AERONAUTICAL CHARTING MEETING Instrument Procedures Group Meeting 22-01 – April 25-26, 2022

RECOMMENDATION DOCUMENT

FAA Control # 22-01-369

Subject: Improve IAP Alternate Minimums

Figure 1: TIST Alternate Mins Publication

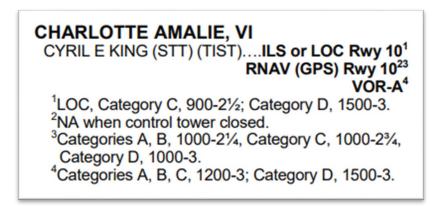
In some cases, this has led to alternate minimums that are more permissive than the approach itself. See TIST, ILS or LOC RWY 10 and VOR-A, wherein the alternate minimums appear unconstrained by tower closure status, while the "standard" approach plates both show "Procedure NA when control tower closed" note.

- Review of alternate criteria to avoid a situation wherein alternates are more permissive than the standard approach, and
- An improvement to the abbreviated amendment/P-NOTAM process to consistently restate (or cancel) alternate minimums textual restrictions at each amendment. As an example, see PANC IL07R, AMDT 4A PNOTAM:
